CREMATORY/PATHOLOGICAL INCINERATOR

TO: Paul Kopietz  
FROM: Evan B. Merz  
SUBJECT: Preliminary Review of Mechanical Plans and Specifications  
JOML-Crematory Addition  
Jackson Hall, Minneapolis Campus, Project No. 032-77-0333

MEMO TO: JOML Crematory Addition File  
MEMO BY: Bruce E. Johnson  
DATED: 17 January 1979  
SUBJECT: Response to the University Review Comments to JOML Crematory  
Addition Contract Documents.

JOML CREMA-  
TORY ADD'N.  
ADDENDUM NO. 1

PARTIAL PLAN - BSM'T. JACKSON HALL

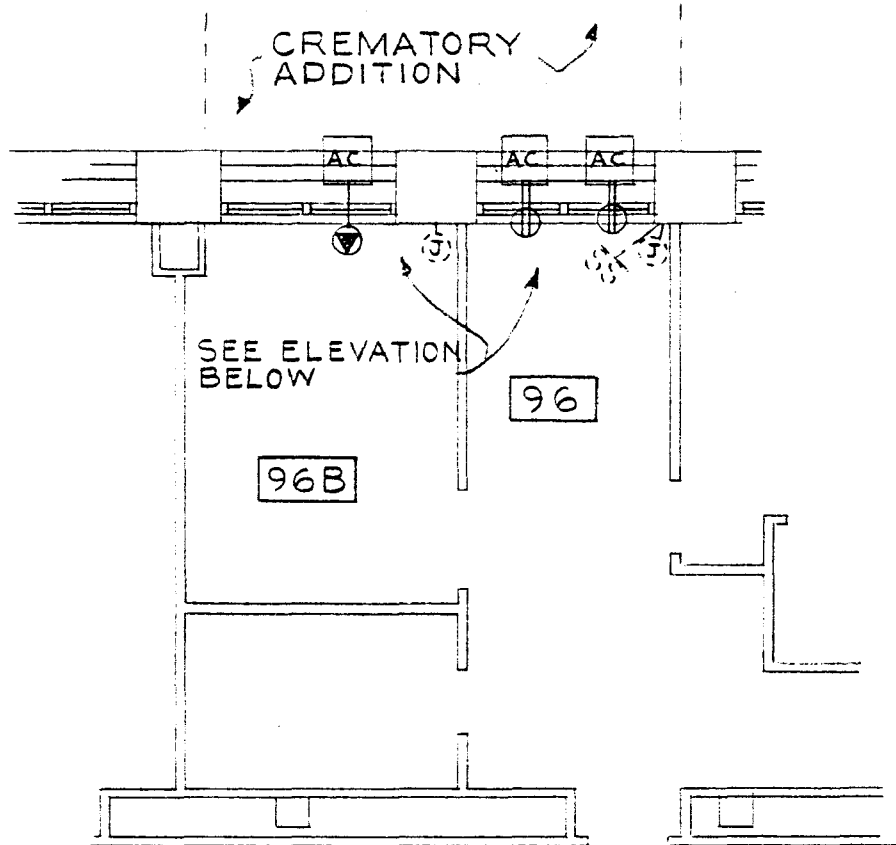
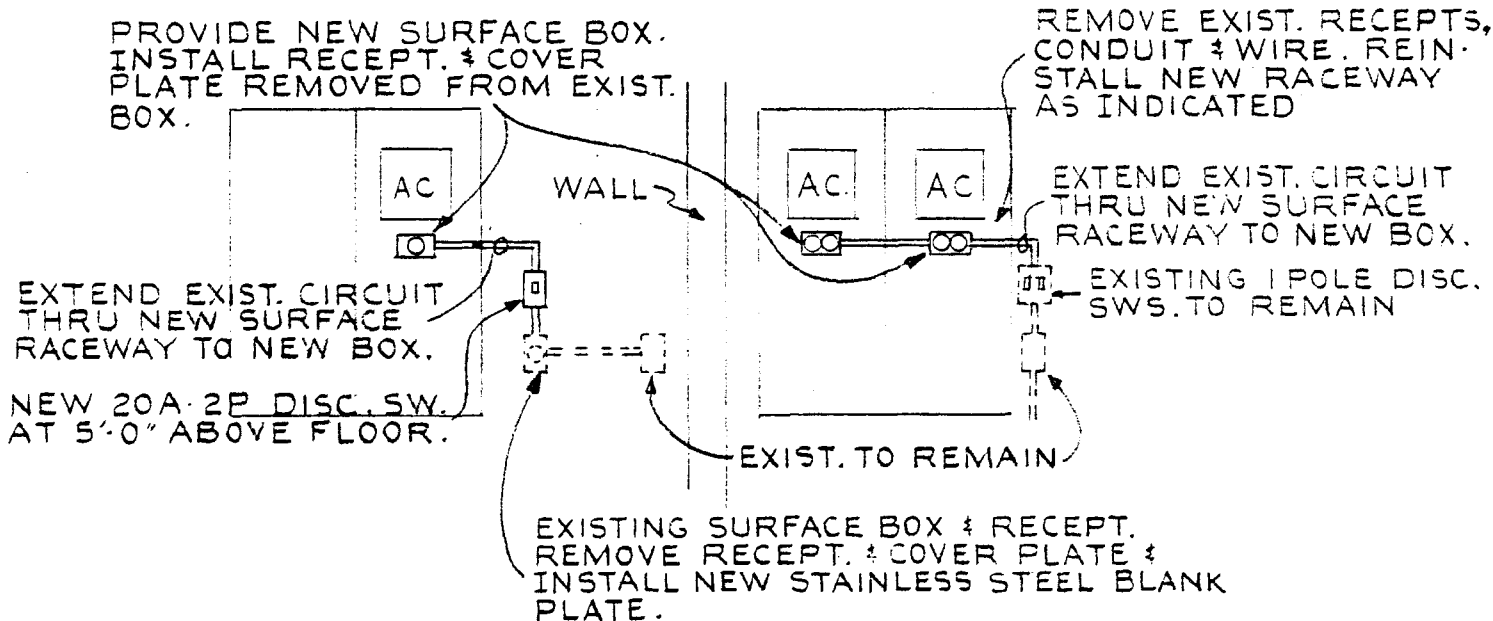
6 - Sheet E-1: (A) Motor Schedule. For motors #1 and #6 change reference of fractional starter to "Manual" starter equipped with thermal protection.

(B) Details #3 and 3a. Delete details #3 and 3a. See attached drawing #1, dated April 13, 1979, for revised power circuits for A.C. unit installation.

This will be Modification 3-E and you should receive a final copy next week.

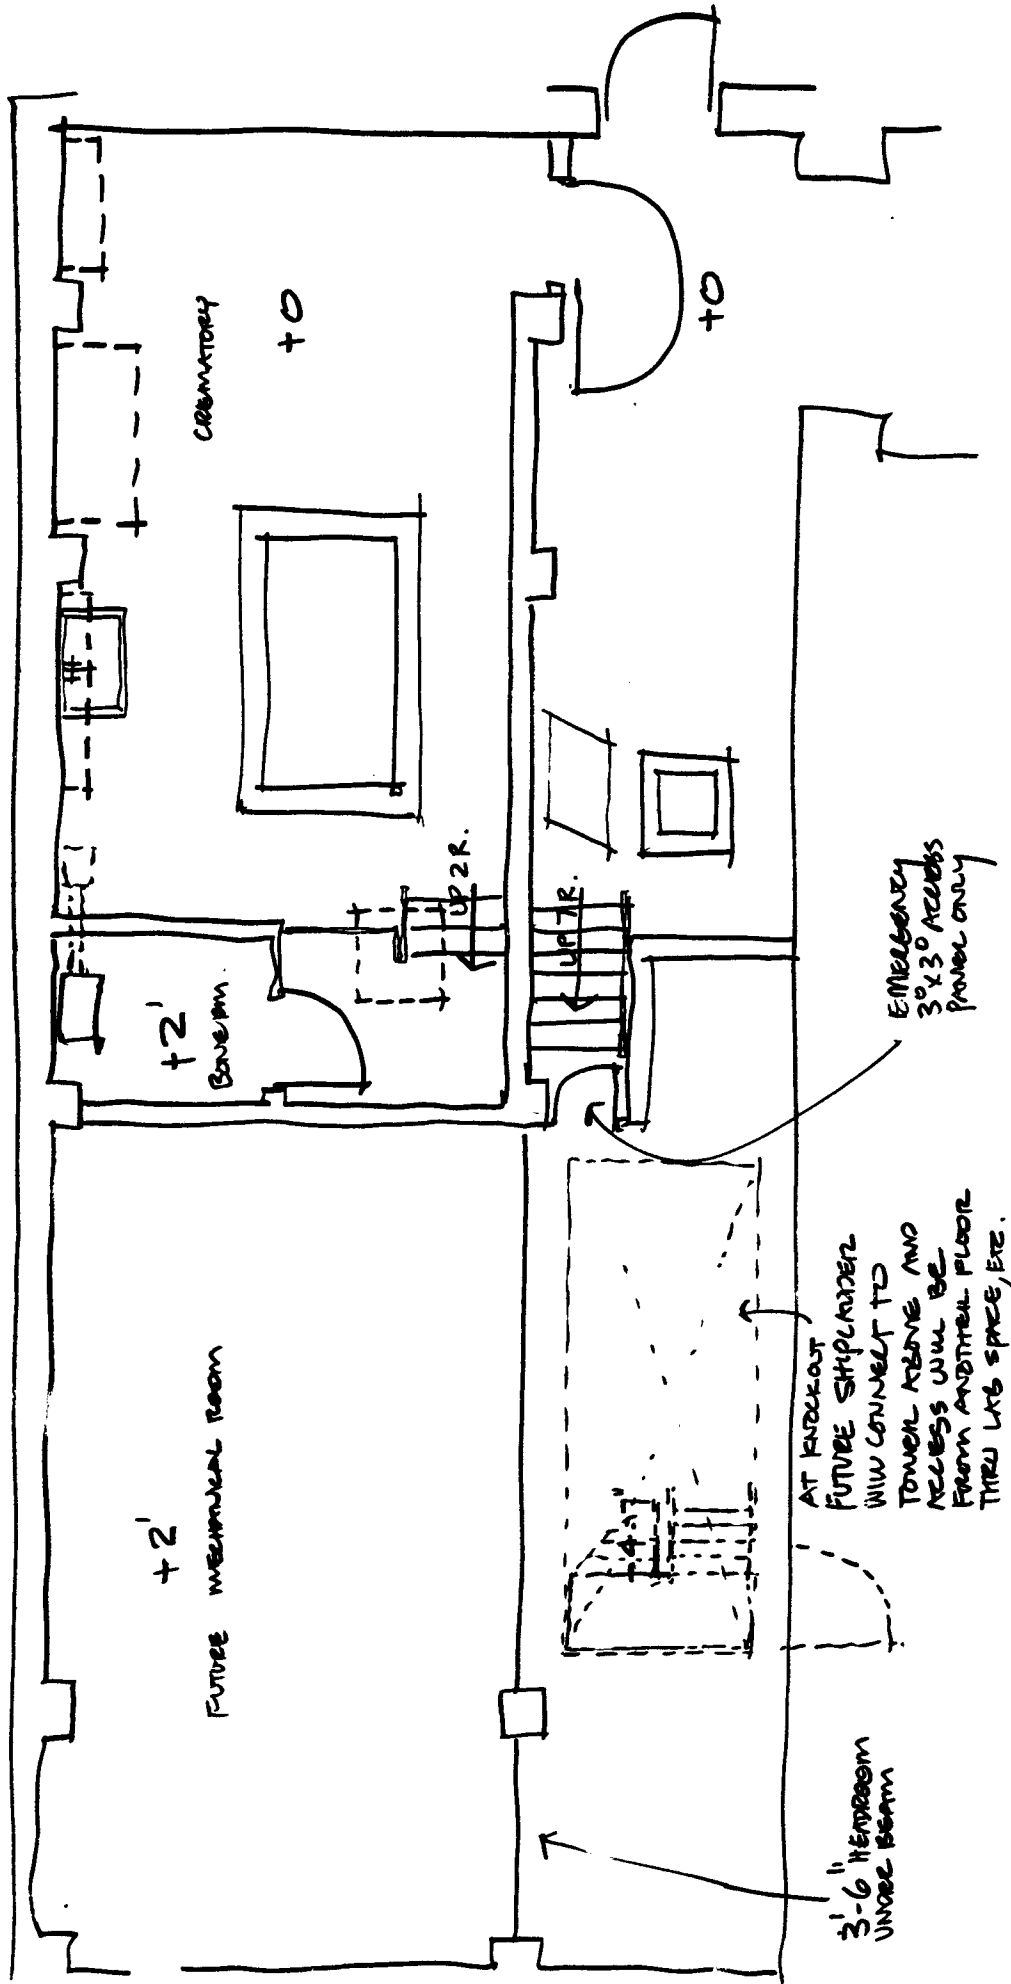
After again discussing the problems with this new solution at our meeting today, I drew the enclosed sketch as a compromise which should be verified as acceptable. Two things need acceptance: raised level of the bone room and treating access from mechanical room sub-basement level as emergency access (tower access will be from floors above in future). We are now proceeding with this solution unless we are told to change.
